FREDERICK COUNTY HISTORIC PRESERVATION COMMISSION STAFF REPORT

Address: 3513 Urbana Pike, Urbana Meeting Date: August 4, 2021

Case No.: COA 21-04 Staff: Amanda Whitmore

Proposal: Brick Replacement

Fig. 3: Photograph of subject property's south elevation in the mid-1980's

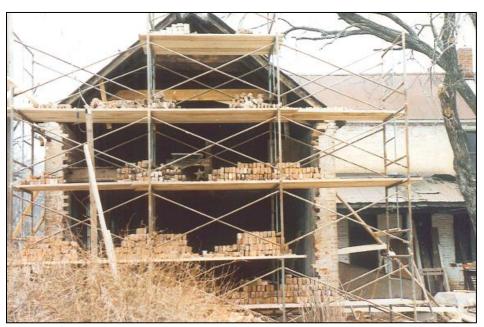
the northeast. The brick is laid in a common bond pattern with flush mortar joints. Review of the County Register nomination materials reveals that the south elevation wall was completely rebuilt in the 1980's. Concrete block now forms the structure of the south wall with salvaged brick on the exterior. The applicant was approved by the Commission shortly after designation in 1999 to repoint sections of the building on the northwest and northeast elevations (COA #99-01).
